# RENESAS TECHNICAL UPDATE

Product Category	MPU&MCU	Document No.	TN-720-A065A/E	Rev.	1.00
Title	Completion of improvement of "Note when writing to 4283 Group QzROM"		Information Category	Technical Notification	
Applicable Product	M34283G2GP, M34283G2-XXXGP	Lot No.	Reference Document	---	
		---

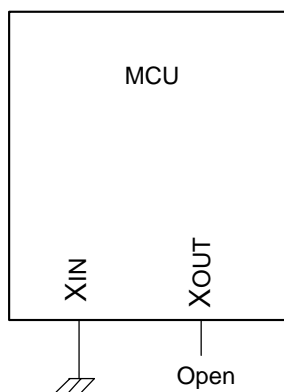
When writing to 4283 Group QzROM, note the following;

Circuit example (1)

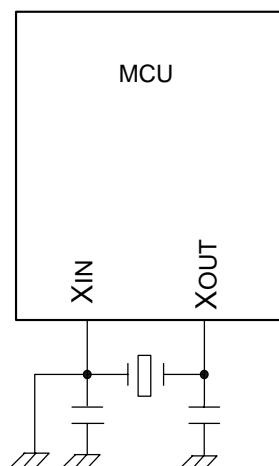
If an external ceramic resonator is oscillating when writing to 4283 Group QzROM, writing may not be performed correctly.

When writing to QzROM, set the XIN pin and XOUT pin to (1) or (2) shown below.

1: Connect XIN pin to Ground and leave XOUT open.

2: Connect a ceramic resonance circuit between XIN and XOUT externally, and connect XIN pin to Ground.
